# **Wisconsin Department of Transportation**

Proposal #07: 1060-28-70, WISC 2017 317 1228-21-71, WISC 2017 319

Marquette Interchange Valley Bridge IH43/IH94

This is Addendum No. 02, which provides for the following:

Revised Sheet 264

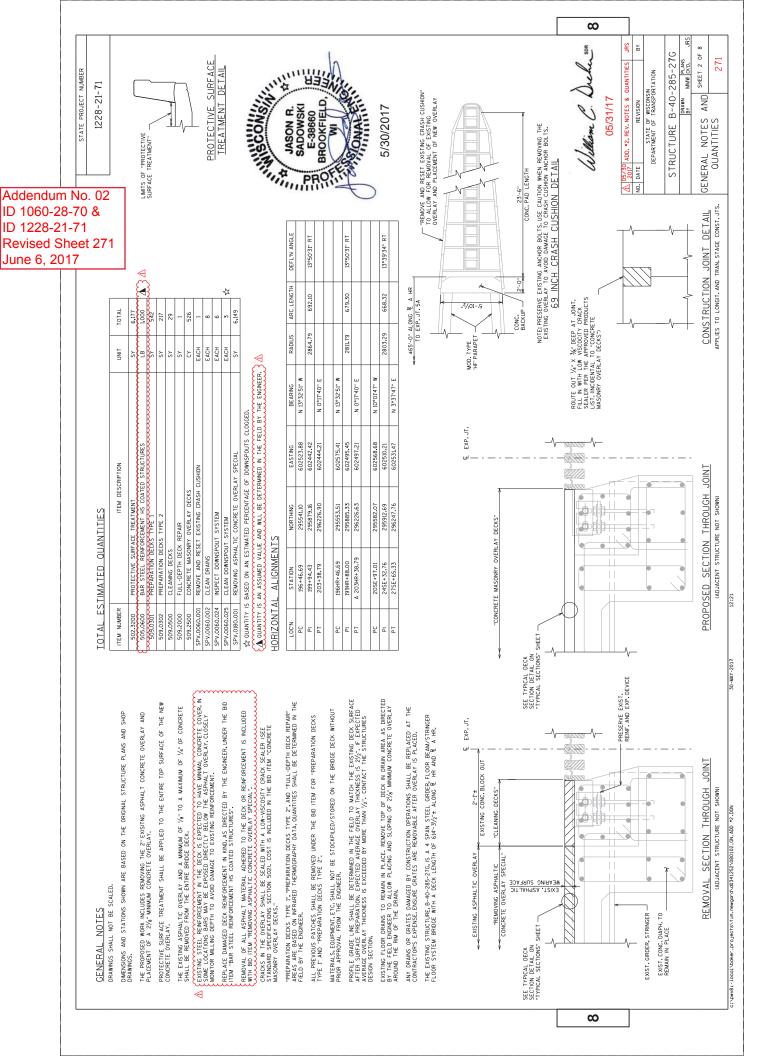
256	Structure B-40-285-27E-2 – Revised quantities and notes				
264	Structure B-40-285-27F-2 – Revised quantities and notes

| 05/30 | ADD. =2, REV. NOTES & QUANTITIES | 2017

DMS SIGN PANEL CONNECTION DETAIL

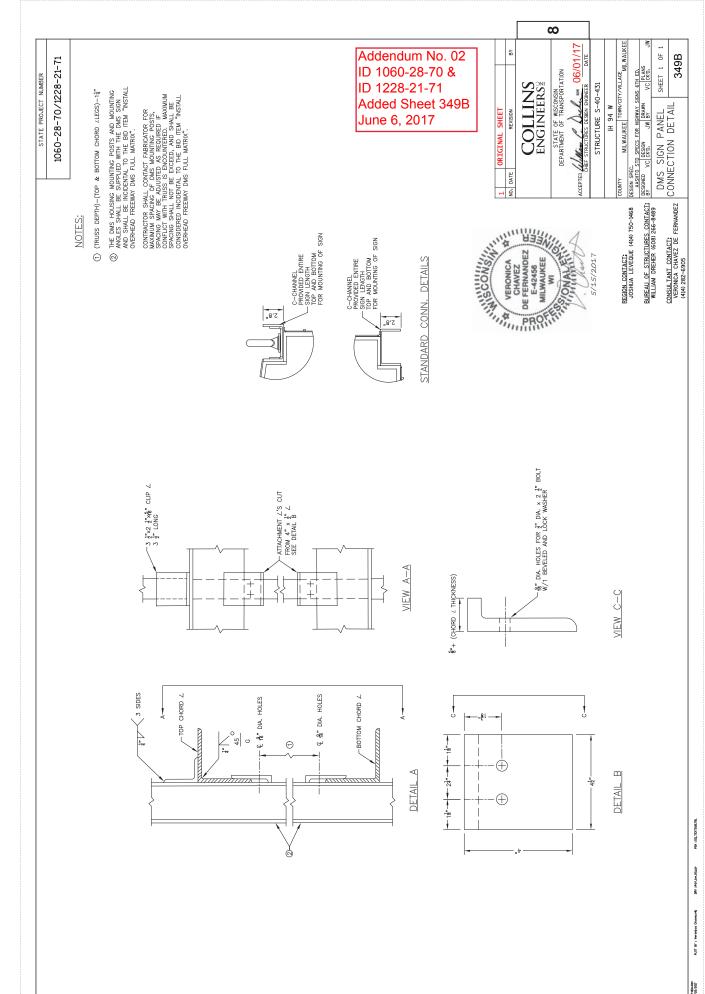
2540	Sign Plates –sheets were not included with advertised set.				
349A	Sign Structure S-40-403 – DMS Sign Panel Connection Detail				
349B	Sign Structure S-40-431 – DMS Sign Panel Connection Detail
